Rezoning Transportation Analysis

Petition Number: 2020-134

General Location Identifier: 05548104, 05548107, 05548105

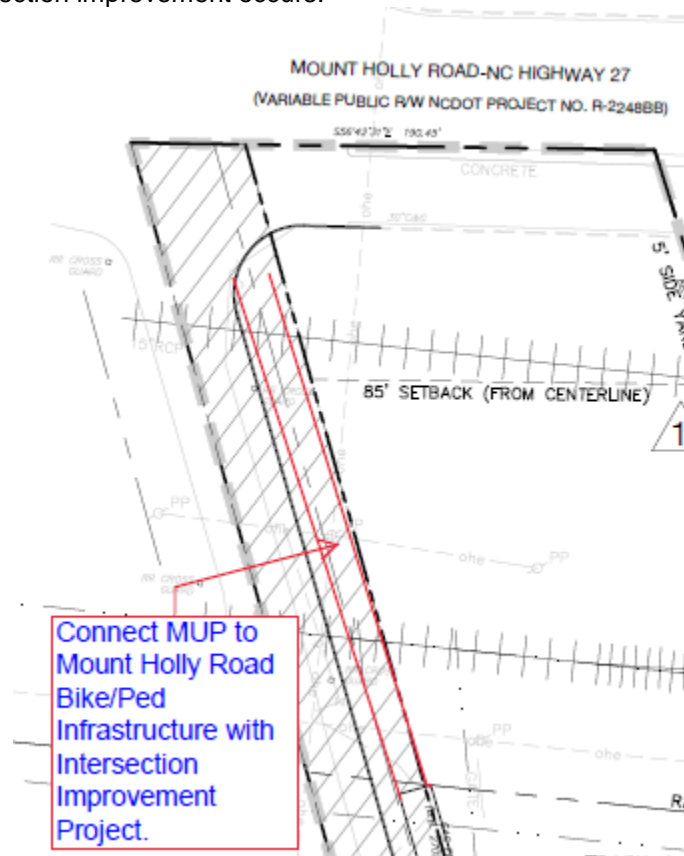
- a. ~~Mt. Holly Road:~~ Revise the site plan and conditional note(s) to commit to dedicate 55-feet of right-of-way from the road centerline. ~~Update as a result from 11-16-2020 Site Plan:~~ Dedicate as much ROW as possible without encroaching into the Railroad ROW.
- b. ~~Rhyne Road:~~ Revise the site plan and conditional note(s) to commit to dedicate 41-feet of right-of-way from the road centerline. ~~Update as a result from 11-16-2020 Site Plan:~~ 40-feet of ROW dedication is acceptable.

The site plan should label and dimension the right-of-way from the road centerline.

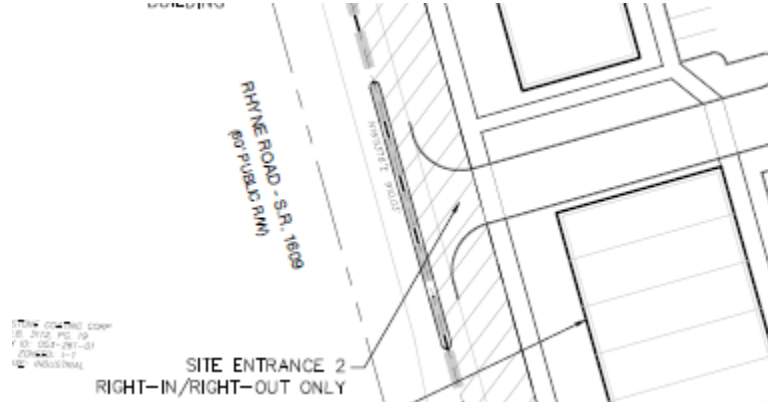
5. ~~Rescinded.~~ Revise the site plan to show, label, and dimension the center lane median, on Rhyne Road, in front of Site Entrance 2, that will direct the right-in right-out movement(s). Also, include the commitment to construct this center lane median in the conditional notes.
